10074
17/8
Re. Building on plot No. 659. J. M. 3.

Plan No. 41/7 Jm3 Sheet Janstad Qr.Plan for BungalowThe above plot submitted by Mr. Santbas Dammal

With reference to your application dated 20th October 1939,
with a plan for the proposed buildings/additions and alterations on plot
No. 659 Survey Sheet No. J.M.3, Jamshed Quarter,
I have to request you to comply with the following requirements—

AMENDED PLAN OF BUNGALOW ON
PLOT N^o 659 (42/10) J.M., 3, JAMSHET Q^r

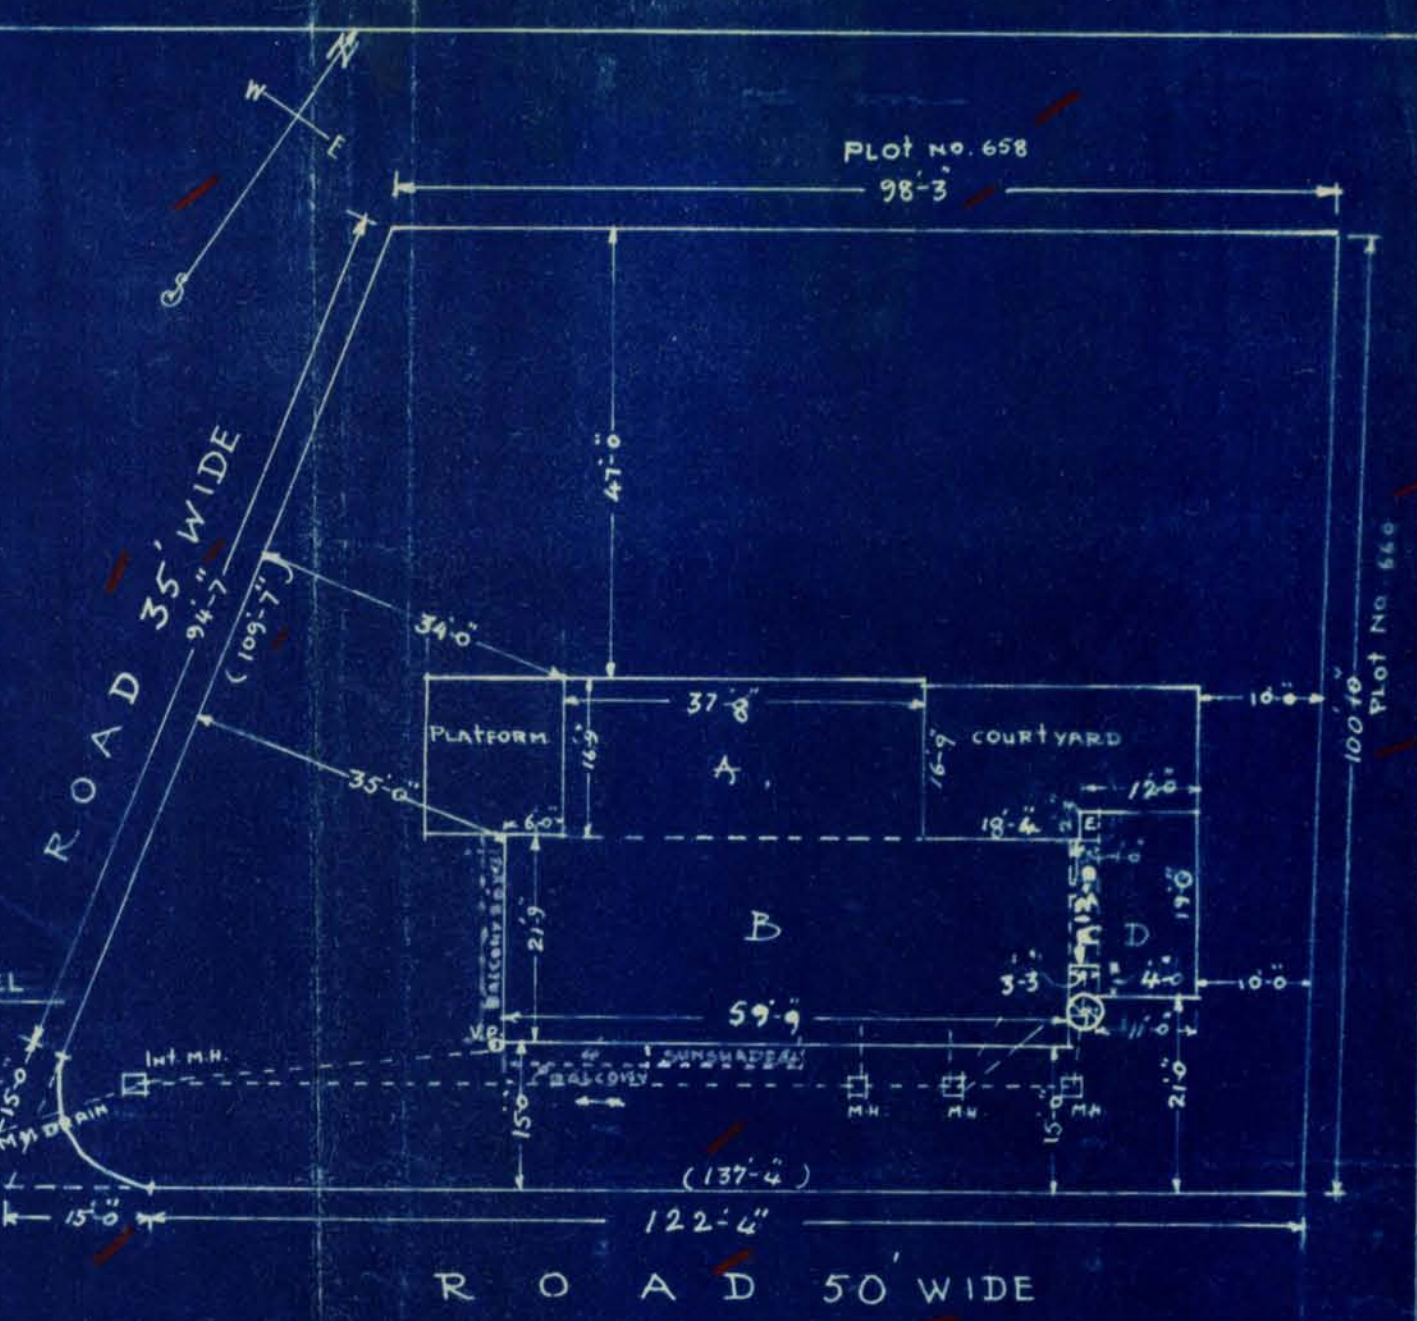
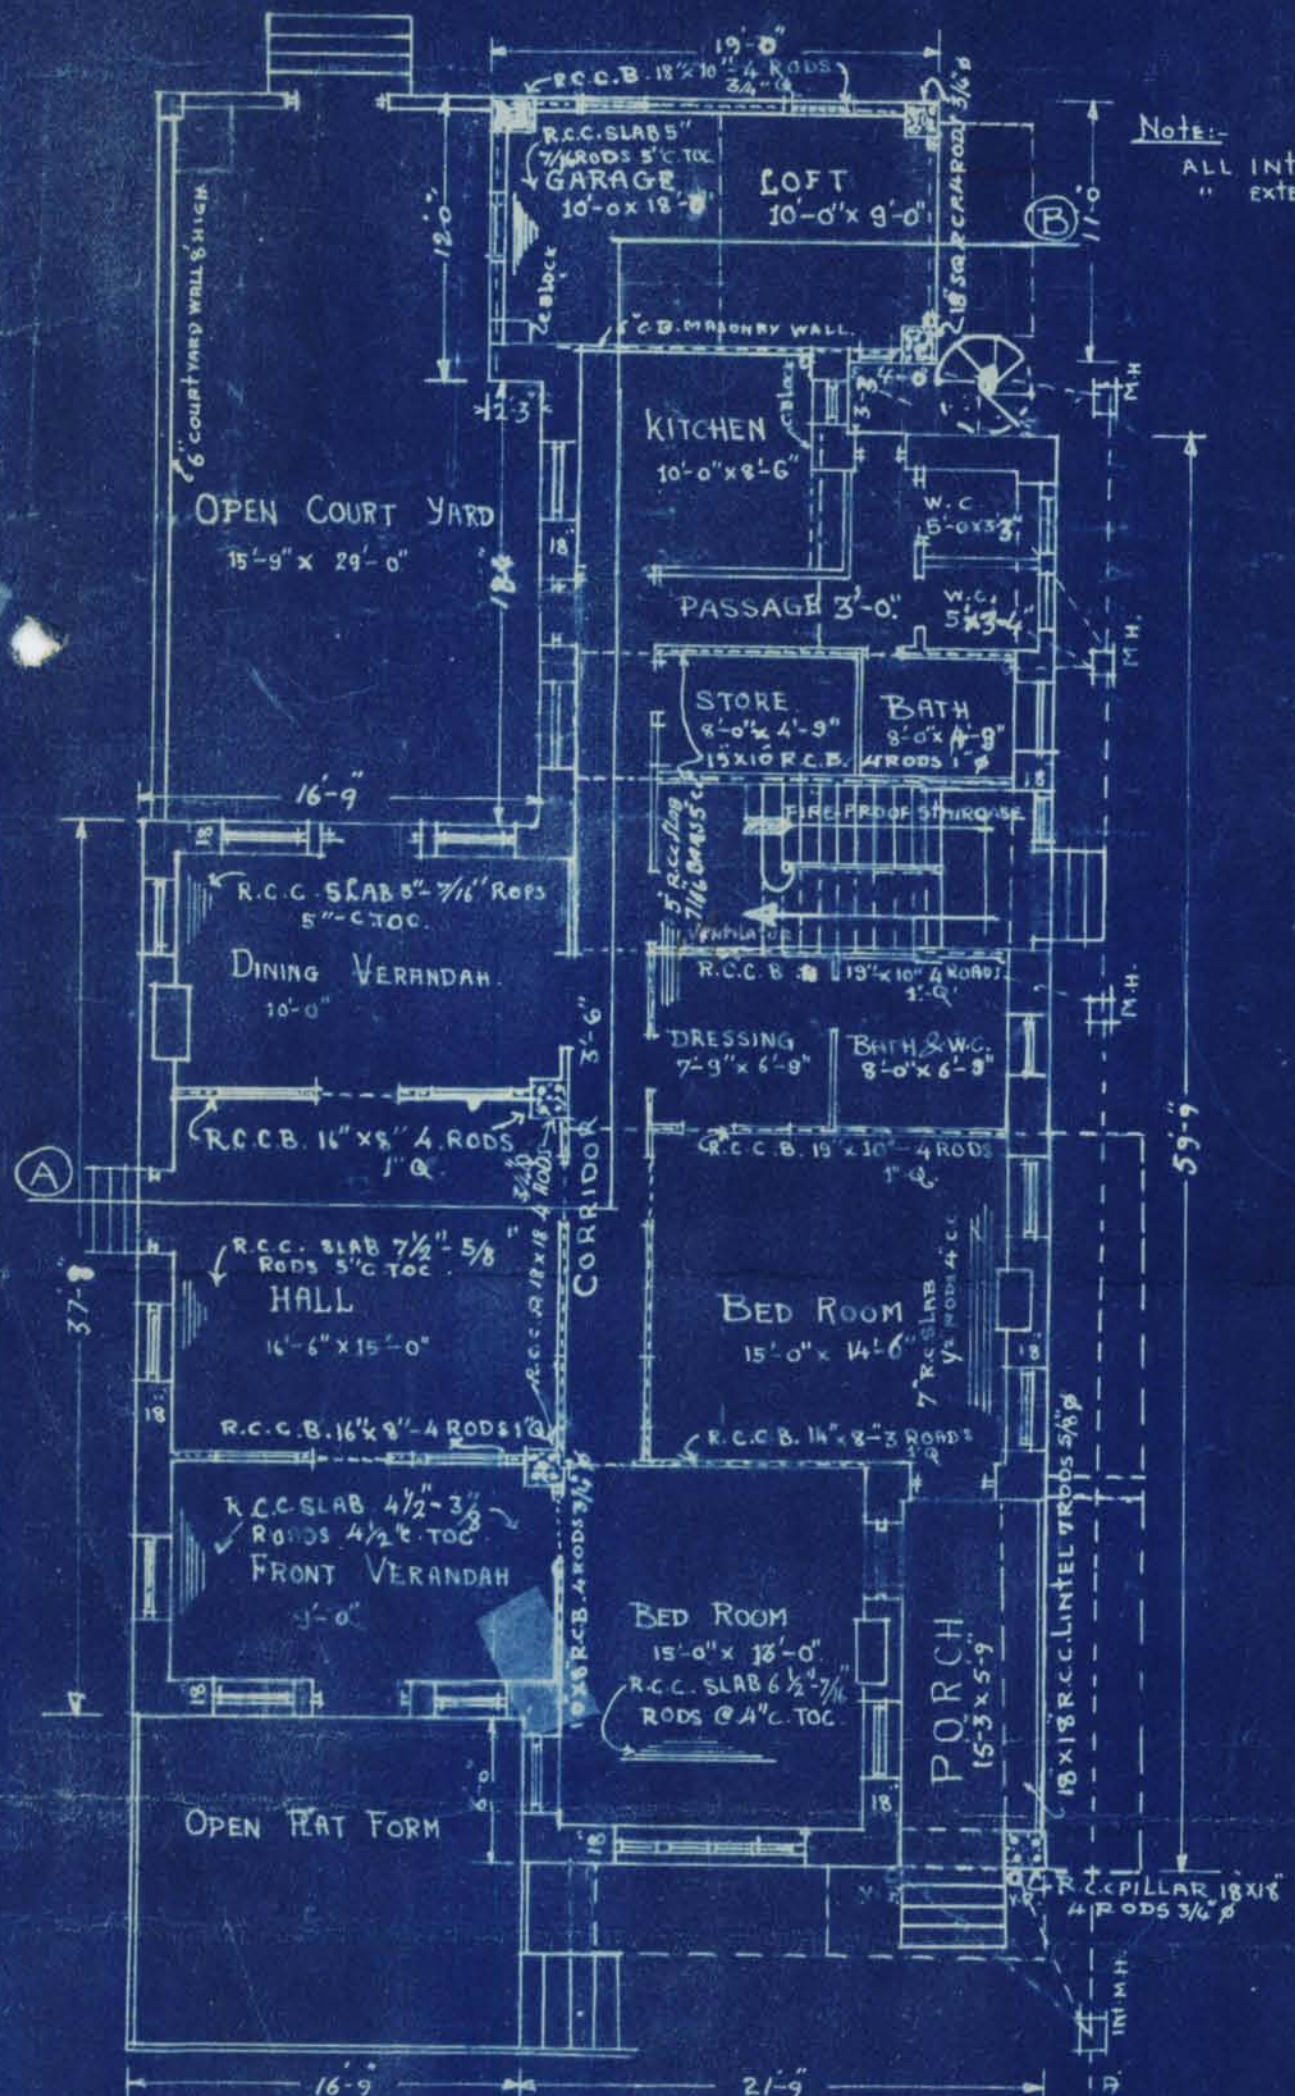
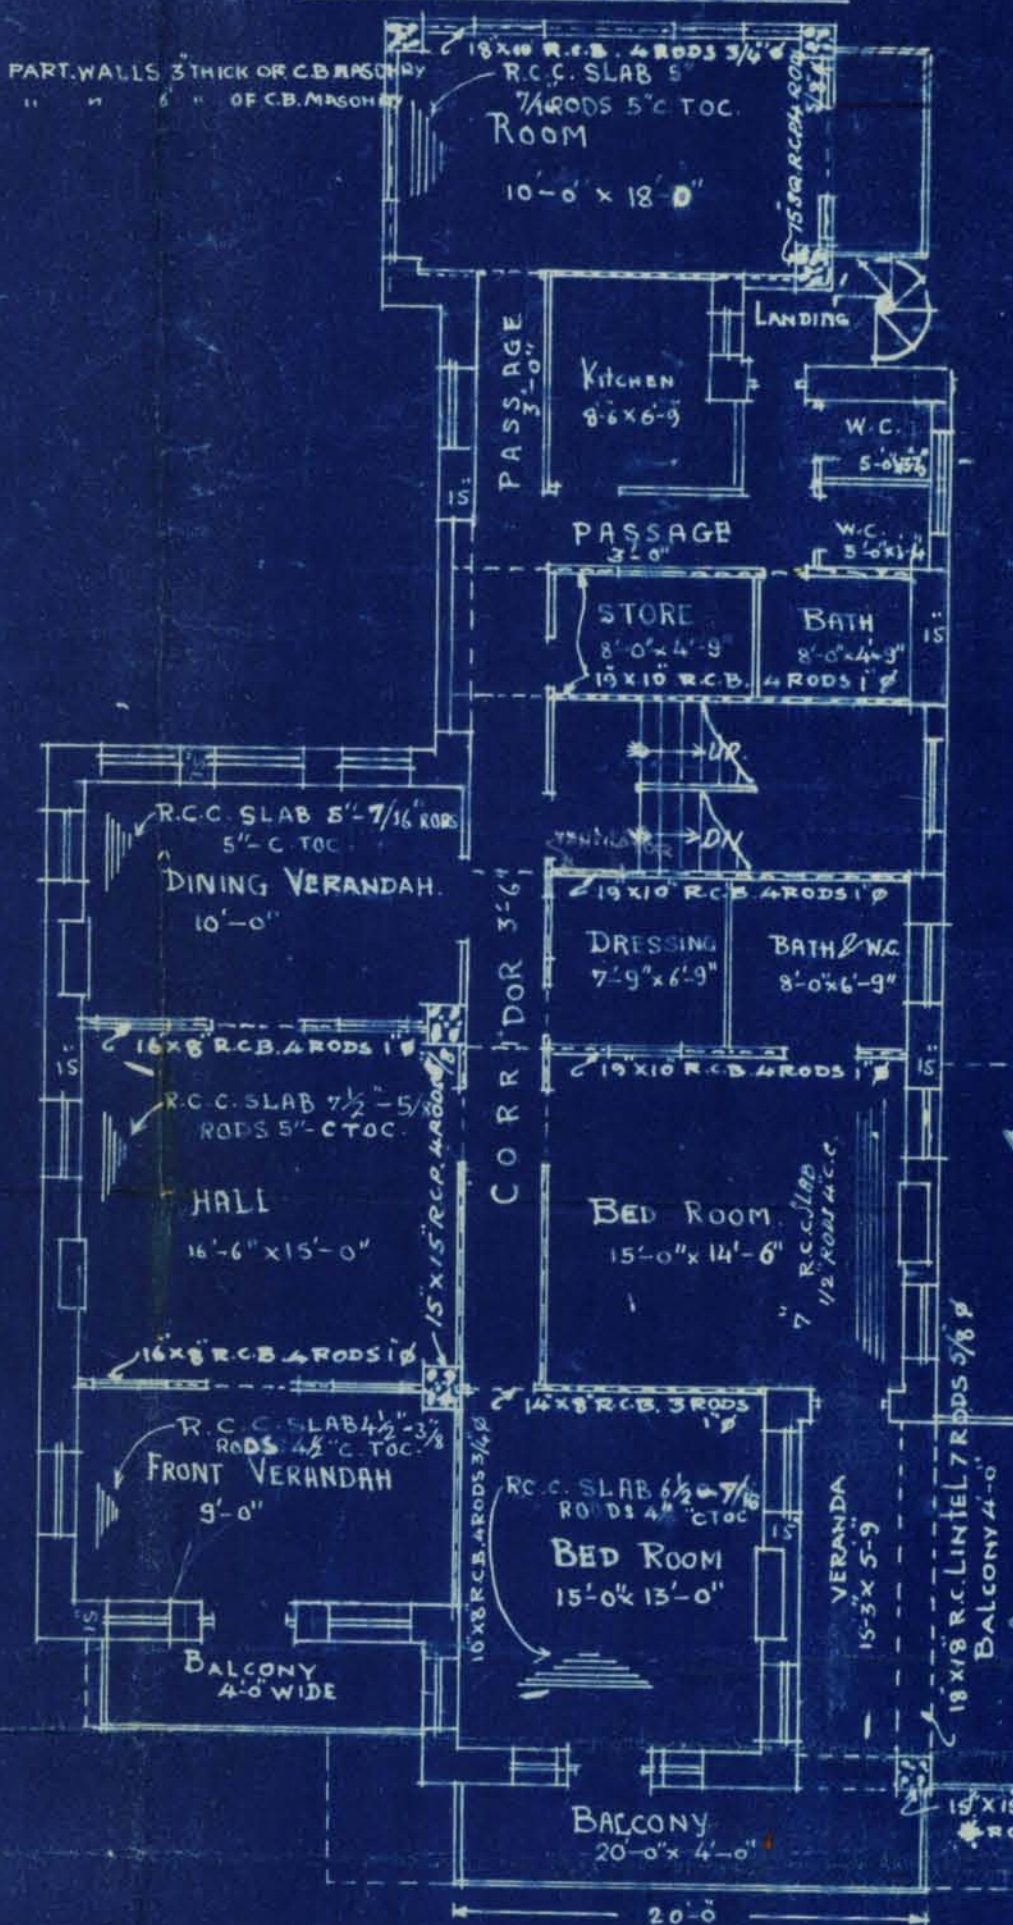
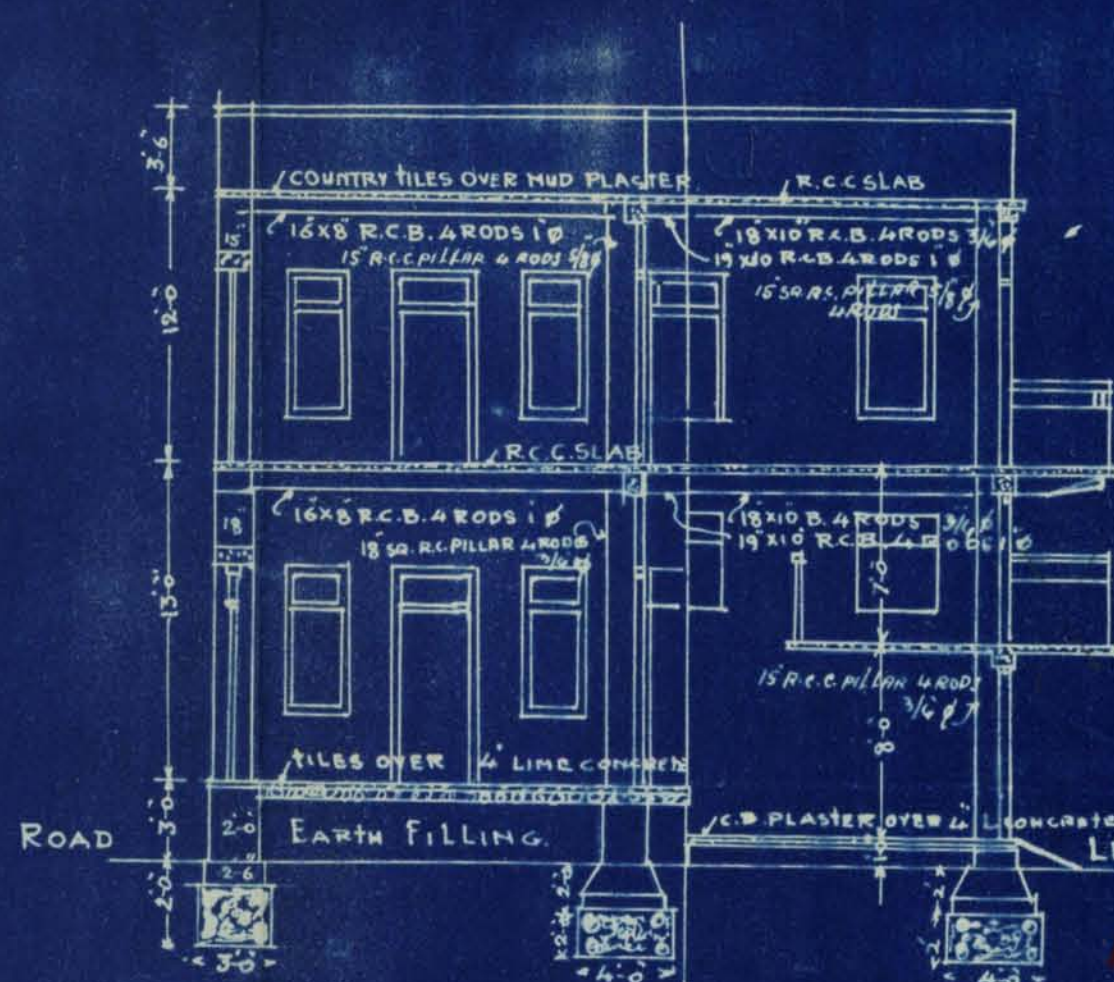
2. Some portions of the site plan cannot be read. Please supply better prints.
3. In the site plan balcony projections must be shown.
4. Under the conditions of sale no structures except platform can be allowed within 15'-0" from the road boundary. Therefore balconies and chajjas within 15' from the road boundary cannot be allowed.
5. Balcony cannot be allowed to loft which is not meant for living purposes.
6. Please state if the so called landing adjoining the spiral stairs will be covered at the top in which case it will have to be taken as built up area.
7. "Dressing room" will be dark and ill-ventilated.

- (1) Landing to the loft forms a balcony, which cannot be allowed.
- (2) Dressing room will be dark.
- (3) It must be put down in the plan that the landing to the spiral staircase will be open to sky.

Re.objection No.1. Landing to the
the loft is built as per approved plan.This
is an amended plan and this is not a new
proposal in it.

Re.objection No.2.Ventilator has
been provided for light.

Re.Objection No.3 is complied.
